Access Compliance Report

Public Rights-of-Way

Intersection ID: 48957	Main Street: POLLYS_GARDEN_CR	Cross Street: FRANKLIN_SQUARE_RD	Location: NE
ADA ID: A8BE09EE776B	Ramp Type: Perp	Initial Pass/Fail: Fail	Overall Compliance: No
		Severity Score: 1.25

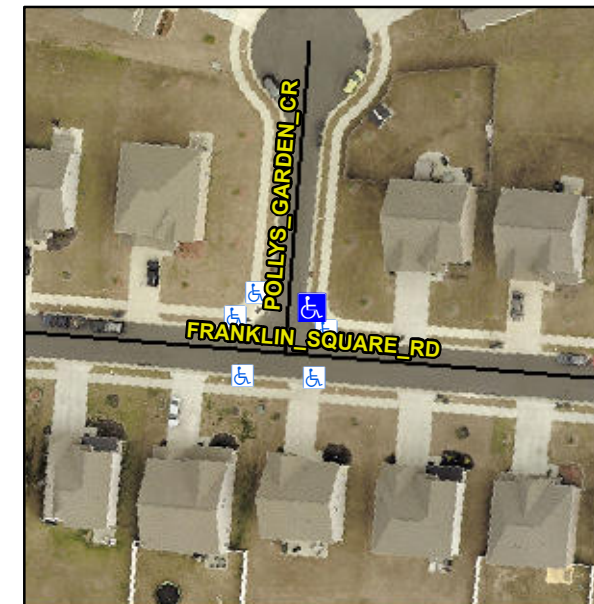
Not Found, R304.5.3

Compliance	Description	Data	Compliance	Description	Data
N/A	Ramp Length (in)	47.5	Yes	Ramp Slope (%)	5.2
Yes	Ramp Width (in)	48.0	No	Ramp XSlope (%)	3.3
N/A	Flare Type LT	N/A	N/A	Flare Type RT	N/A
N/A	Flare Slope LT (%)	N/A	N/A	Flare Slope RT (%)	N/A
N/A	Flare Traversable LT?	N/A	N/A	Flare Traversable RT?	N/A
N/A	Landing Length (in)	N/A	N/A	DWS Provided?	N/A
N/A	Landing Width (in)	N/A	N/A	DWS Contrast?	N/A
N/A	Landing Slope (%)	N/A	N/A	DWS Length (in)	N/A
N/A	Landing X Slope (%)	N/A	N/A	DWS Full Width?	N/A
N/A	Landing Curb? (Y/N)	N/A	N/A	DWS Offset (in)	N/A
N/A	Shared Landing?	N/A			
N/A	Gutter Ponding?	N/A	N/A	Gutter Slope (%)	N/A
N/A	Gutter Lip Ht (in)	1.0	N/A	Gutter X Slope (%)	N/A
N/A	Painted X Walk1?	No	N/A	Painted X Walk2?	N/A
	X Walk 1 Direction	To NW		X Walk 2 Direction	N/A
N/A	X Walk 1 Width (in)	N/A	N/A	X Walk 2 Width (in)	N/A
	X Walk 1 Slope (%)	4.5		X Walk 2 Slope (%)	N/A
	X Walk 1 X Slope (%)	0.1		X Walk 2 X Slope (%)	N/A

Remove & Replace Entire Ramp.
